REMARKS

Application No. 10/694,630
Paper Dated: May 15, 2006
In Reply to USPTO Correspondence of February 16, 2006
Attorney Docket No. 964-031639

AMENDMENTS TO THE DRAWINGS

FIG. 1b

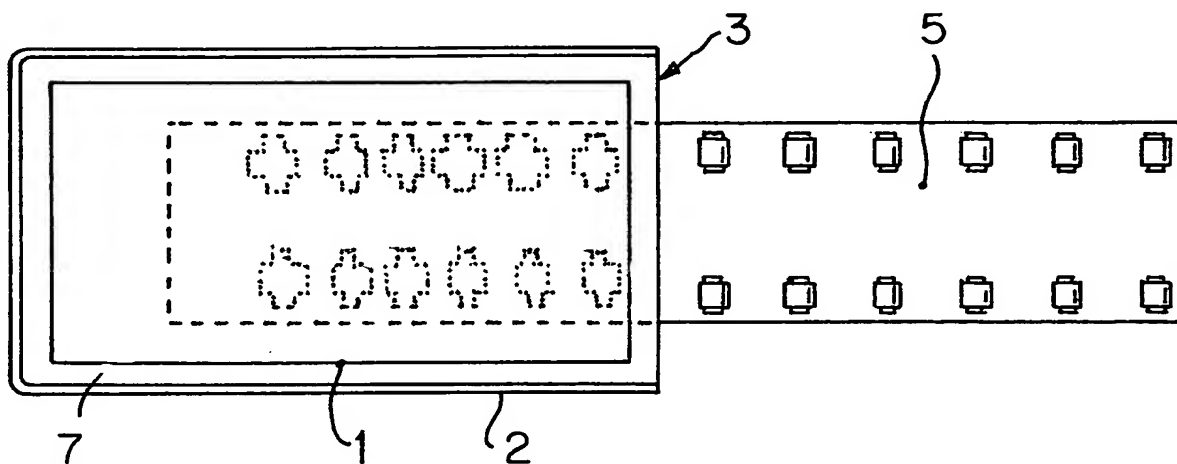
On page 2 of the Office Action, the Examiner required drawing corrections to Figs. 1b, 2b, 3b, and 4b to place these figures in conformance with conventional drawing rules. Applicants enclose herewith drawing sheets showing proposed drawing corrections to Figs. 1b, 2b, 3b, and 4b in red ink as suggested by the Examiner to correct the drawing figures.

Applicants include herewith drawing sheets showing proposed drawing corrections in red ink to Figs. 1b, 2b, 3b, and 4b. Approval of the proposed drawing corrections is respectfully requested.
